**Municipal Services Center, Council Chamber
3600 Tremont Road**

BZAP Meeting Date: November 5, 2025

Subject: 2721 Kent Road (VAR-47-25) - To allow a front porch which results in ~~34.6~~ 31 percent building coverage and ~~57.6~~ 54 percent development coverage, in lieu of the 29 percent and 50 percent maximum limits. *[Postponed from October 15, 2025 BZAP hearing.]*

SITE PLAN

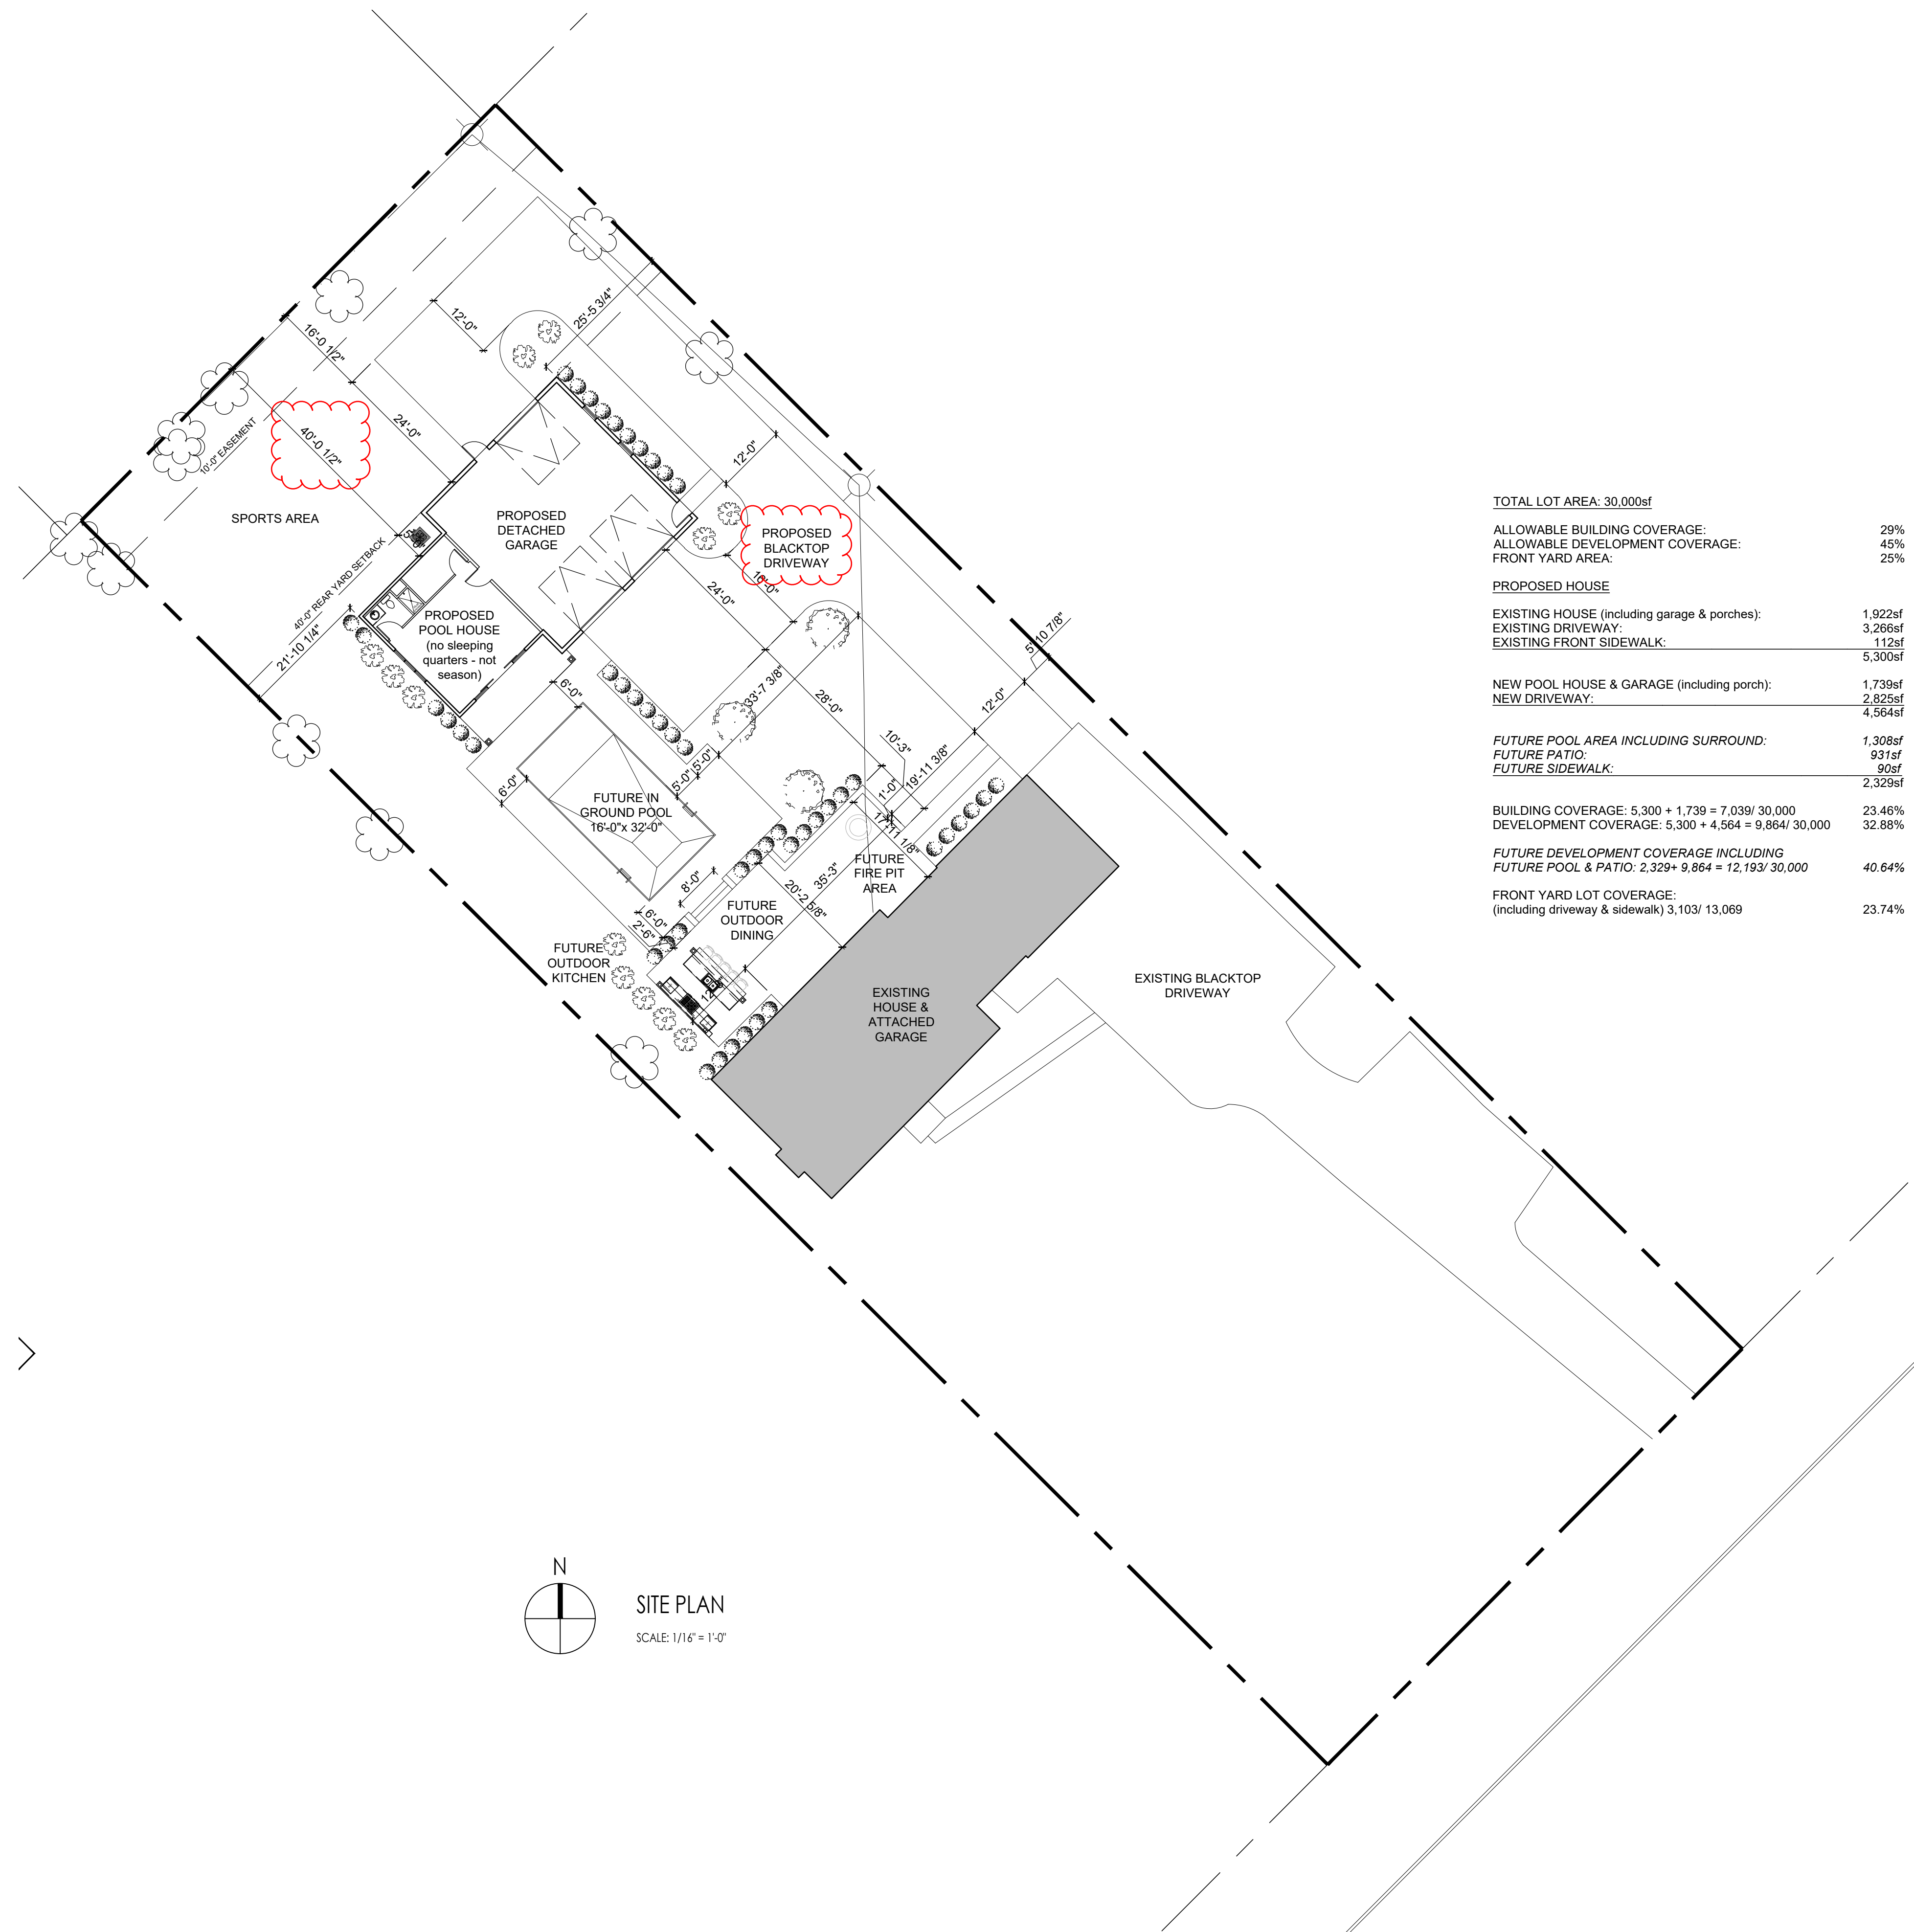
- Access: The existing driveway will be extended with a proposed ~~'chip-n-seal'~~ blacktop surface to provide access to the three garage bays. ~~[Chip-n-seal surfaces are not permitted due to their shorter lifespan, ongoing maintenance requirements, issues with loose stones, and rutting.]~~

*A variance for neighborhood compatibility continues to be cited by Staff due to its architectural style, height, and massing. The revised plans are an improvement from the original and have been approved by the City's third-party architect. Staff questioned whether a stone facade should be added to the detached garage to match the house, but the third-party architect disagreed due to its distance from the home and the street.
